# AMENDMENT

16-43725-AMD-1  
February 9, 1993

## MORTAL KOMBAT Kit, using the T-Unit CPU

*This amendment updates the Mortal Kombat Manual. Please place this information in the manual.*

### Notice: Power Supply

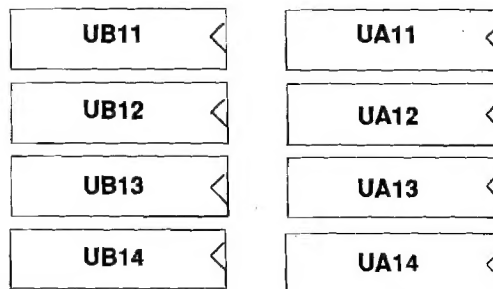
Be sure the power supply from your old game is capable of +5V dc at 5A and +12V dc at 2A.

### Typical Cabinet Wiring

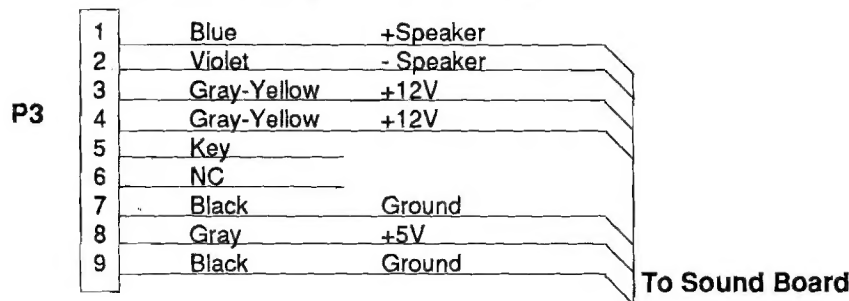
The connector P3 on the CPU should be changed to the following.
